From:	Birge, Tiffany (MRC)
To:	MRC - jpa Permits
Subject:	FW: 2026-WTRA-00009 (NAO-26-00081, VMRC #2026-0055): 1001 Virginia Ave, Shadowlawn Associates, LLC - REQUEST FOR ADDITIONAL INFORMATION
Date:	Wednesday, February 11, 2026 3:47:53 PM
Attachments:	image001.png Outlook-Logo, comp JPA_Plans_Virginia_Ave_02-11-2026.pdf

From: Heaven L. Manning <HManning@vbgov.com>
Sent: Thursday, January 29, 2026 1:59 PM
To: Brian Owen <brian.owen@msaonline.com>; office@wetheringtonhomes.com <office@wetheringtonhomes.com>
Cc: USACE <CENAO-.REG_ROD@usace.army.mil>; JPA <jpa.permits@mrc.virginia.gov>; tiffany.birge <tiffany.birge@mrc.virginia.gov>
Subject: 2026-WTRA-00009 (NAO-26-00081, VMRC #2026-0055): 1001 Virginia Ave, Shadowlawn Associates, LLC - REQUEST FOR ADDITIONAL INFORMATION

PROPOSED DEVELOPMENT

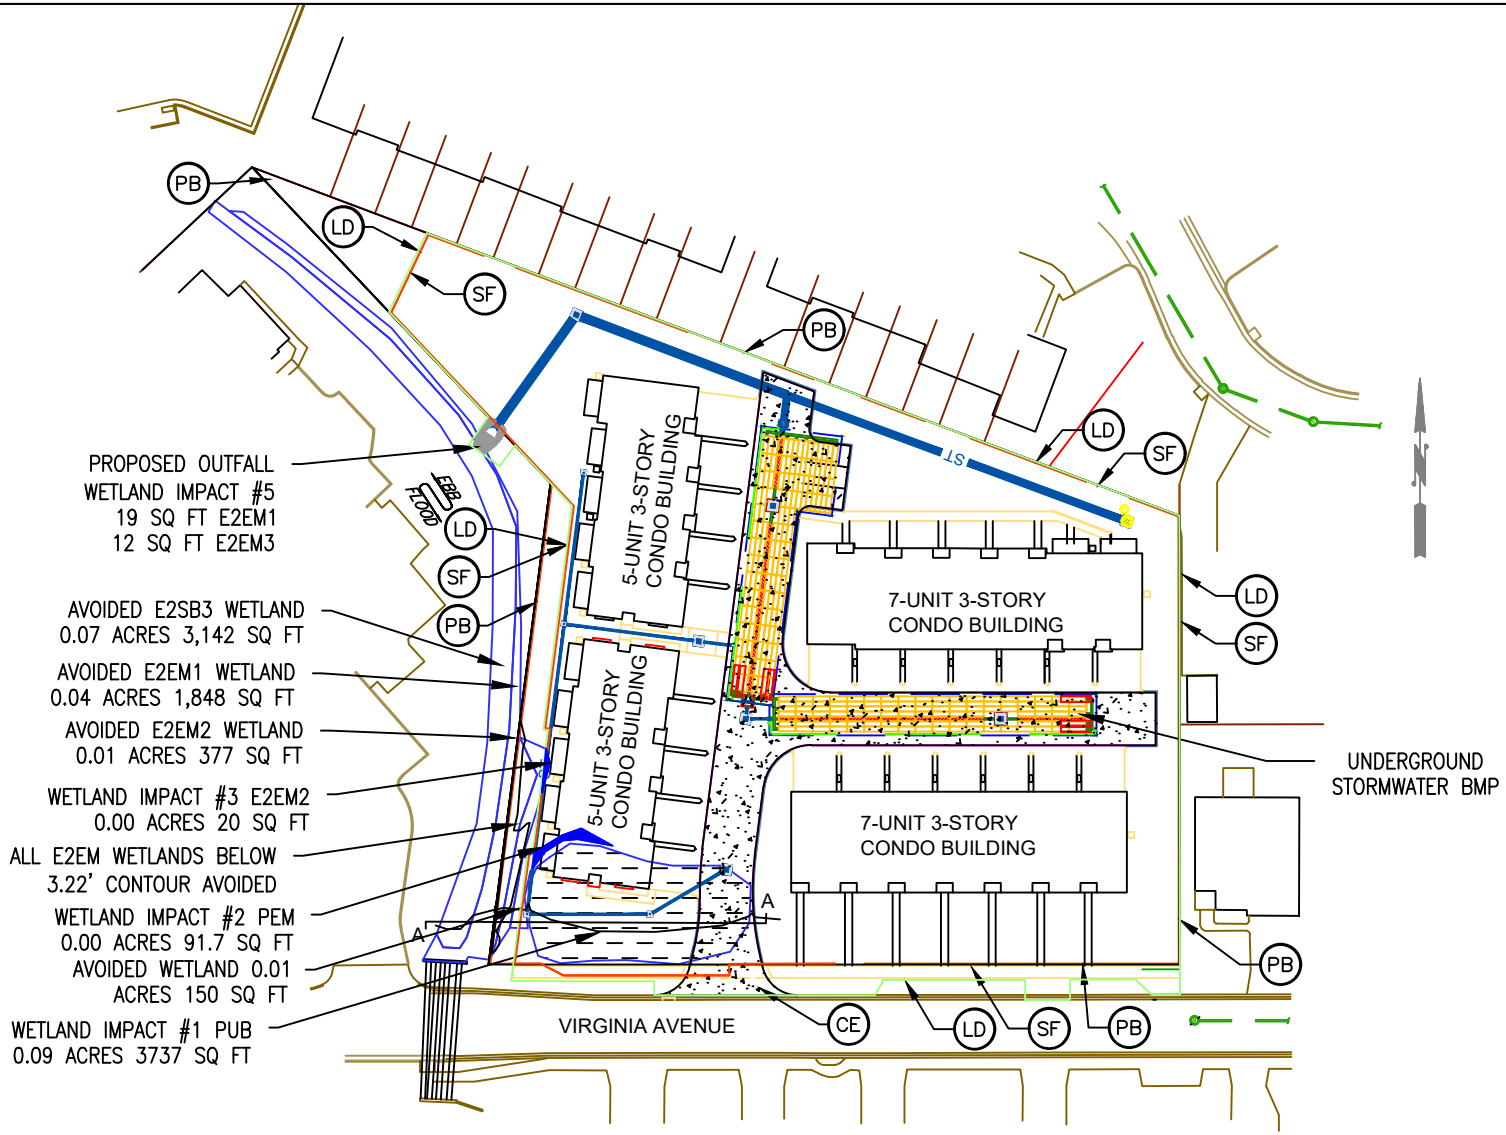
Phragmites is specifically listed for vegetated wetlands in Section 1401 (e) of the Wetlands Zoning Ordinance. Therefore, Wetlands Board jurisdiction extends from MLW to one and one-half (1½) times the mean tide range. Any impacts to wetlands within this range require approval from the Wetlands Board. Please add MHW and 1.5X mean tide range elevations to the plans.

MLW = -1.82
MHW = +1.54
Based on which, the 1.5X tide is +3.22 elevation.

The project engineer, being now aware of this elevation, created the contour and the LOD has been revised to avoid any wetlands within the City jurisdiction. Please see attached updated plans. No permits should now be required from the City wetland board.
